TECHNICAL SERVICE BULLETIN

SB-64 2022 & 2023 Allegro Bay Rear Camera and Signal Lights Update

Tiffin Motorhomes Technical Service Bulletin # SB-64

Purpose: Provide instructions for correcting STOP/TURN/TAIL operations for taillights.

Figure 1

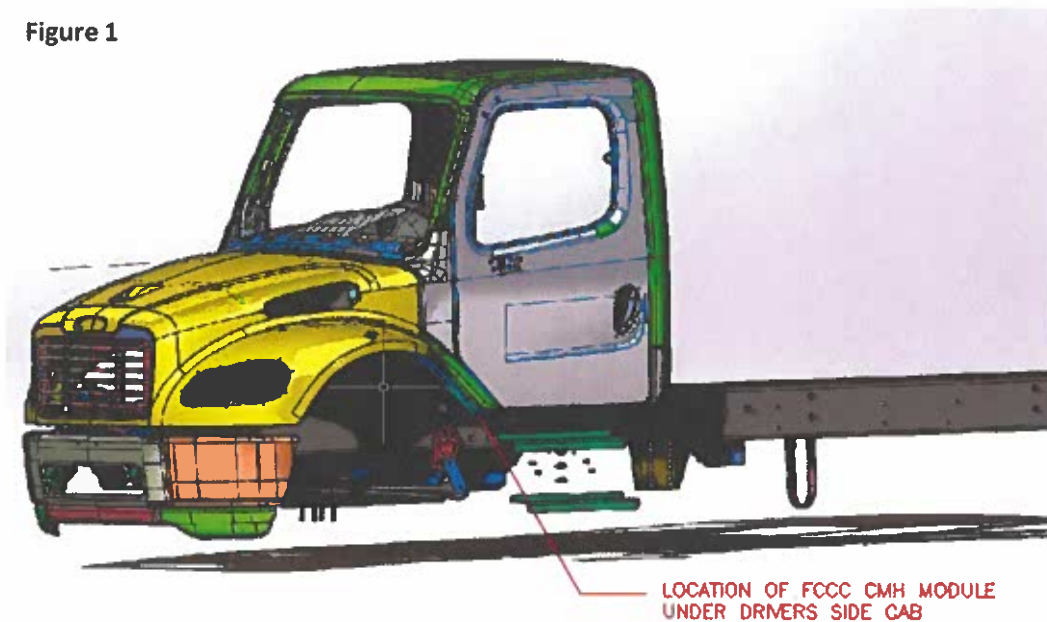
1. Locate FCCC CHM vehicle Module shown in Figure 1.

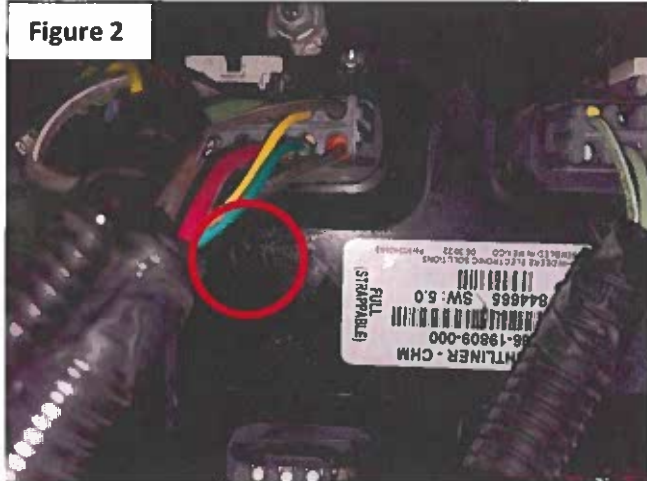
2. Locate the plug on the CHM vehicle module labeled "C4", see Figure 2.

Figure 3

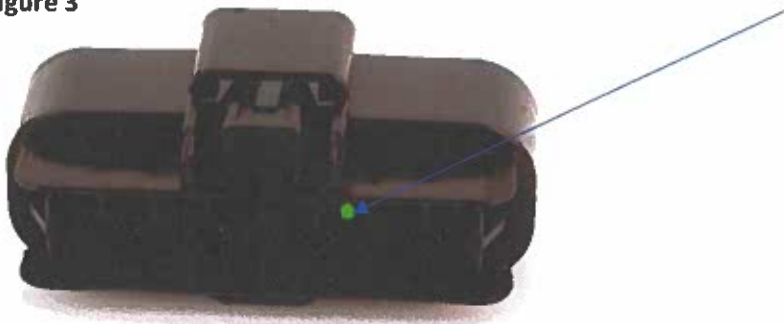
3. Remove plug and disassemble C4 plug from the CHM module. See online video for example, [PCTV HELP - Delphi GT 150 & 280 Connectors - YouTube](#)
4. Run a new wire from the CHM C4C connector pin F through the forward/aft chassis interface connector to pin H of the rear vehicle interface connector.
5. Insert provided wire labeled 'CHM C4-F' into position F, see Figure 3 Reassemble and reconnect plug.

Figure 4

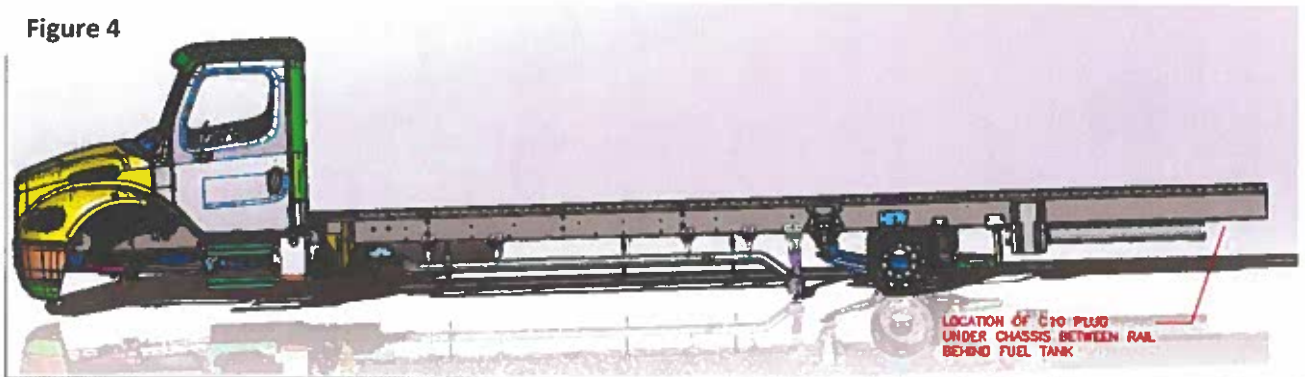
6. Run wire through chassis to rear of coach to the rear cap C10 8 position connection, see Figure 4. Avoid running the wire close to or on any exhaust components or moving drivetrain components. Use cable ties to secure wire in place to prevent movement. Use wire cutters to remove excess cable tie.
